**SUBJECT****Moisture in LED Headlight****MODEL**

Vehicles produced to November 11, 2012

With option 552 “Adaptive LED headlight”

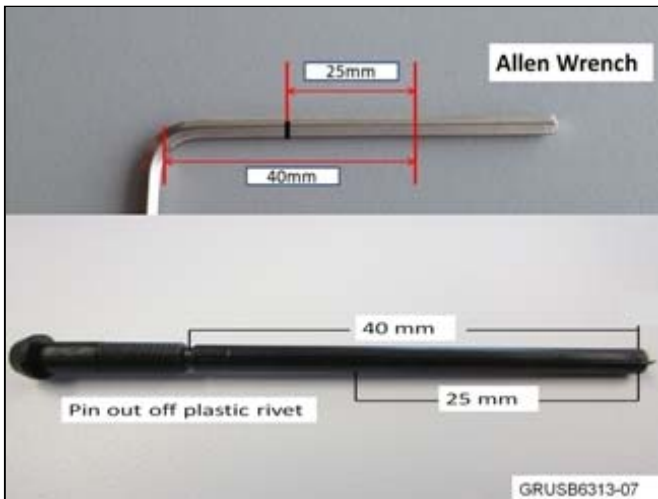
2. With a screw driver, remove the

cap from the headlight as shown in picture.

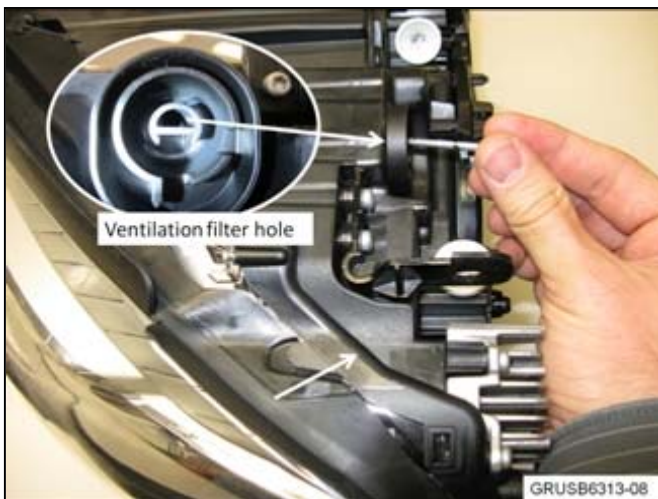
4. The Allen wrench or plastic body rivet pin should be 40 mm long (allowable clearance for the tool in the vehicle). Mark 25 mm of the 40 mm length with paint or something similar: this is the depth limit inside the ventilation filter hole in order to remove the filter.

5. Insert the 3 mm diameter pin or Allen wrench 25 mm into the hole, displacing the filter as shown in the photo. Repeat this process several times. Note: The filter remains inside the headlight, but is no longer needed.
6. Perform this procedure for the other side.
7. Reinstall the cap and cover for both sides.
8. Drive the vehicle or leave the headlight on for about half an
